G190EAN01.3
Engineering Change Notice

2026/03/10

- To ensure long-term supply stability, ADP will introduce a replacement model for G190EAN01. This change will consolidate resources while enhancing supply continuity, manufacturing efficiency, and overall product competitiveness. We are providing this advance notice to ensure a smooth and well-coordinated transition.

EC Item 1 - Panel material & Structure change

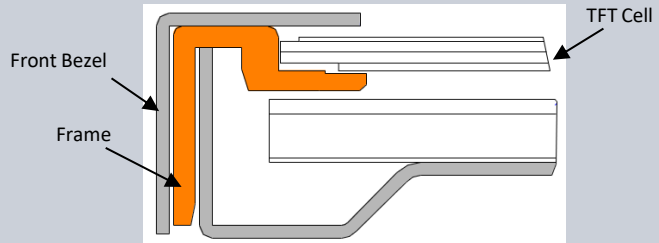
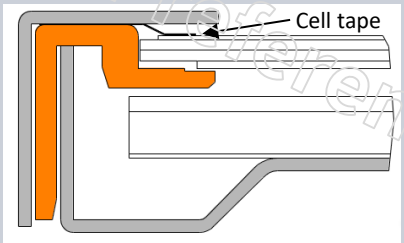
Change Item			(Current) G190EAN01.3 97.19G06.300	(New) G190EAN01.3 97.19G06.310	Remark
OM	Material	Diffuser_U	Keiwa A	Keiwa B	
		Diffuser_L	SKC	Lucky	Supplier allocation
		Reflector	Mitzubishi	Toray	Supplier allocation
	Structure	Cell tape	NA	Cell tape structure	Reinforce the structure to reduce particle intrusion.
		Conduction	Conduction tape	NA	New design doesn't require this tape.

- Cell tape design: Reinforce the structure to reduce particle intrusion.

Overview of Module Appearance Differences

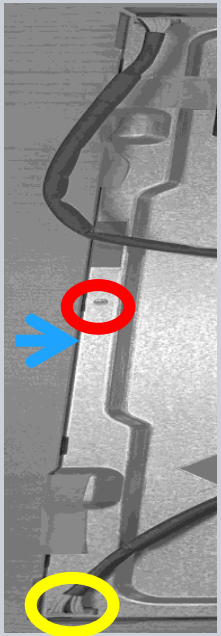
While the module dimensions are identical, three minor aesthetic differences are observable.

① Red-circled area: The positioning of the backlight module material has been relocated downward to enhance its thermal resistance. 	
	② As indicated by the blue arrow: The redesigned plastic frame is moved outward to provide a better dust-proof effect. 	
	③ Yellow-circled area: The LED light bar connector has been changed to a horizontal orientation to prevent damage caused by accidental impact during the assembly process. 	
➢ Cell tape design: Reinforce the structure to reduce particle intrusion.

EC Item 2 - 2D Drawing

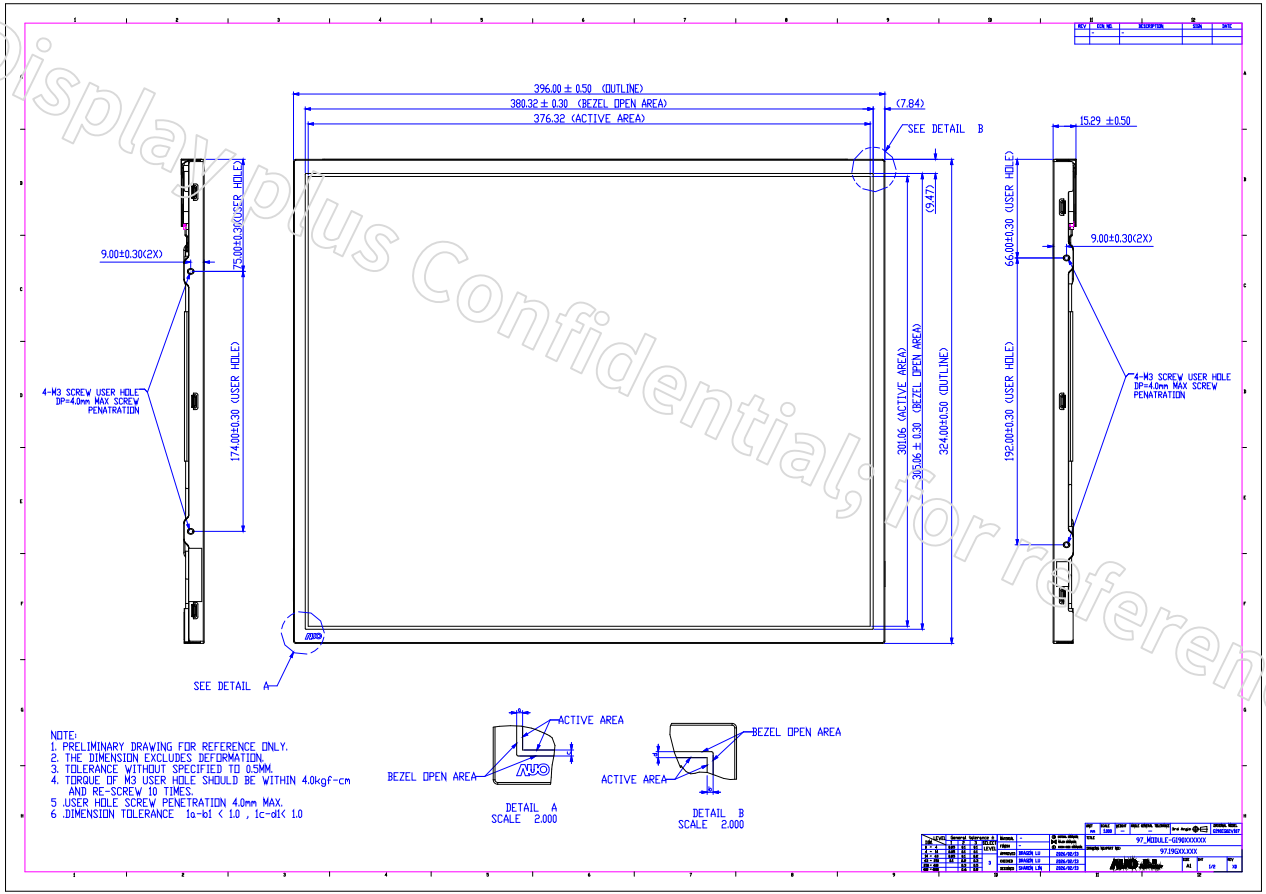
- Front side:

EC Item 2 - 2D Drawing

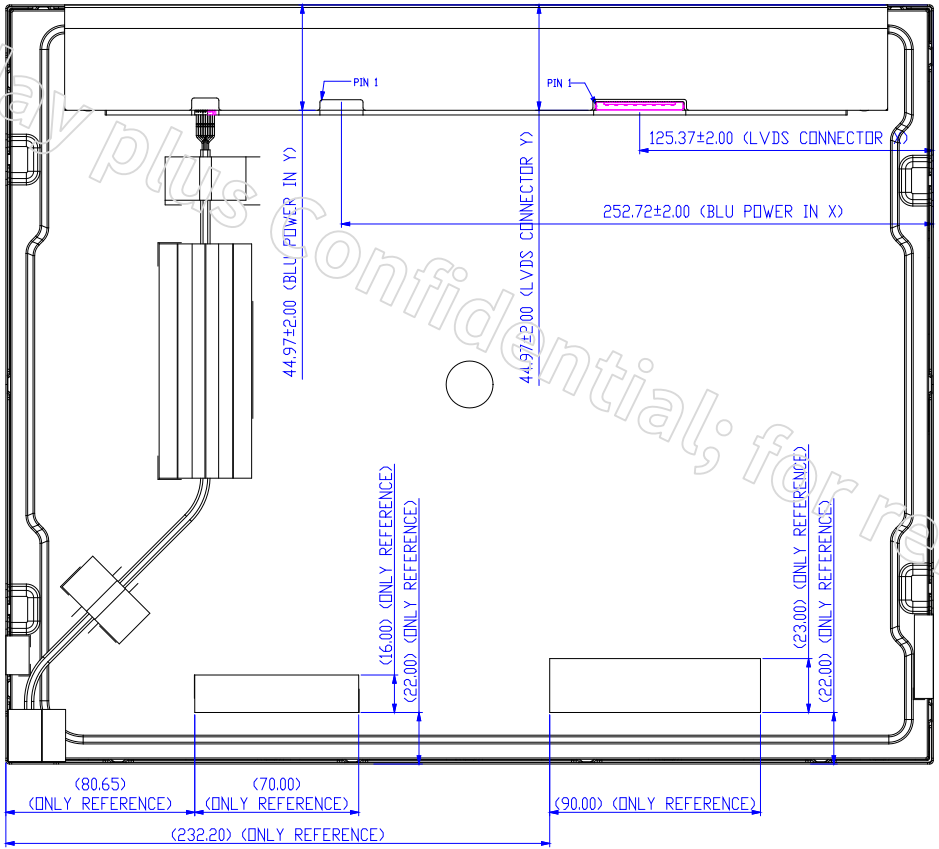
- Back side (remove conduction tape):

EC Item 3 - Label

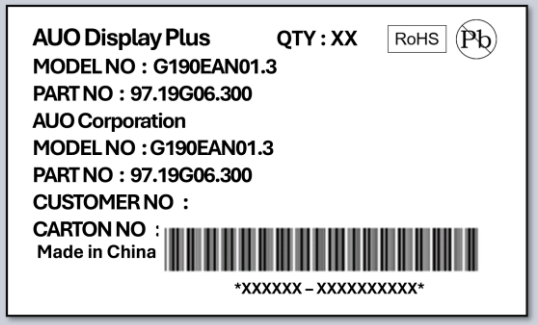
- Shipping label & Carton label
